Some slides presented at  
last FCC week June 2021

## Injector Layout

**Review of FCC-ee injector**

# Guidelines for the future studies

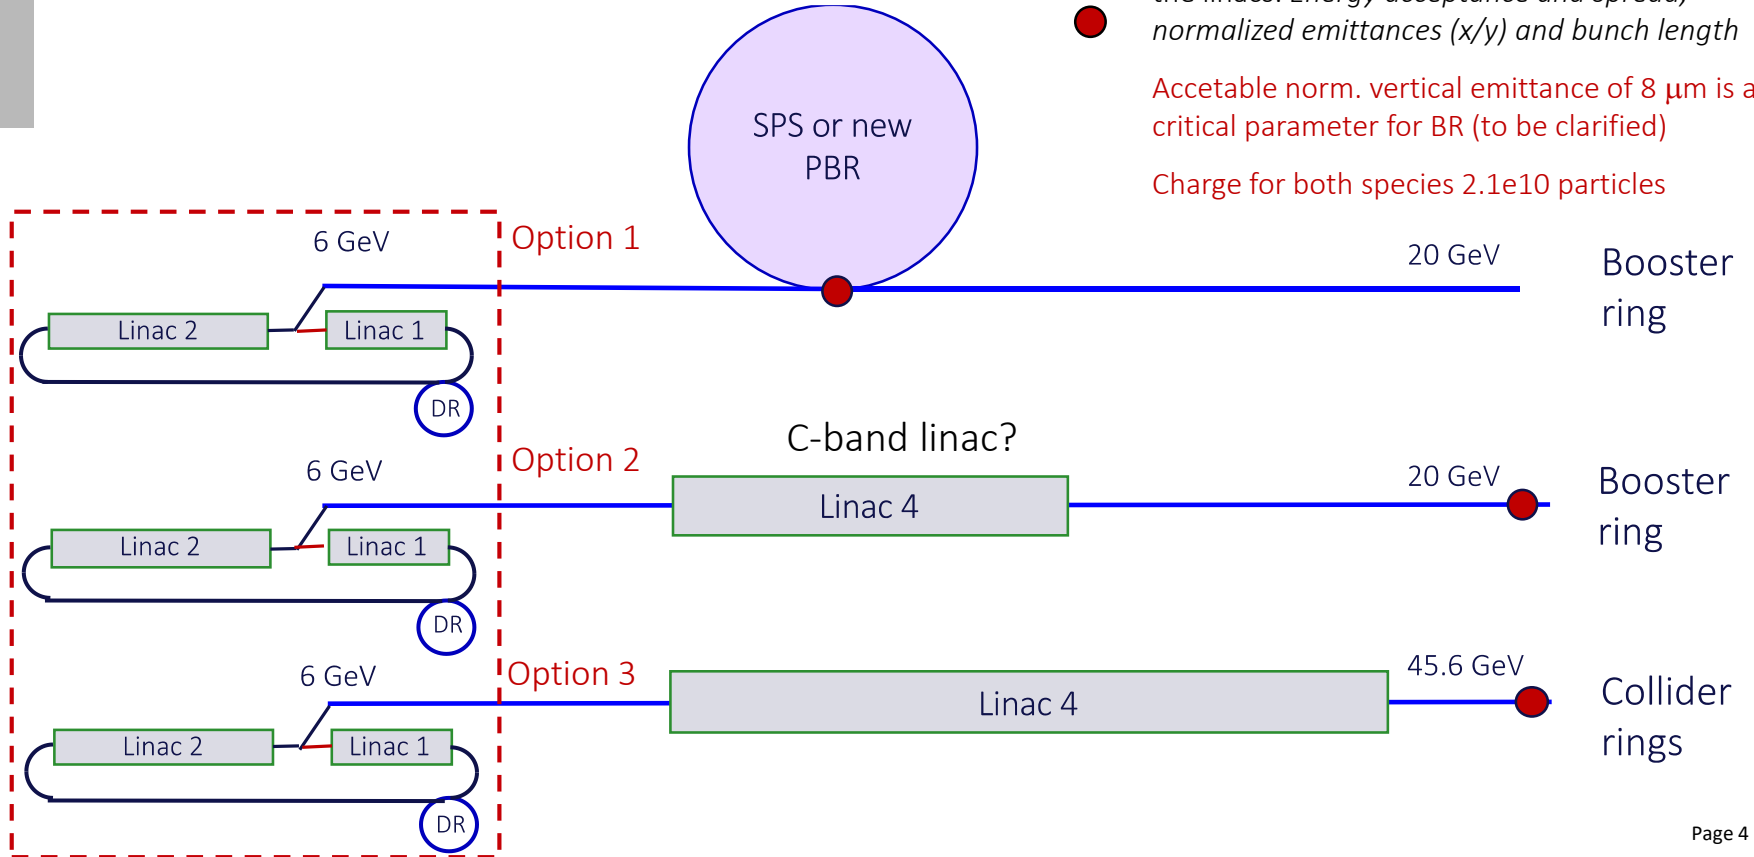
# Three more options for injection into booster ring

- Main beam parameters to be considered for the linacs: *Energy acceptance and spread, normalized emittances (x/y) and bunch length*

Accetable norm. vertical emittance of  $8 \mu\text{m}$  is a critical parameter for BR (to be clarified)

Charge for both species  $2.1e10$  particles
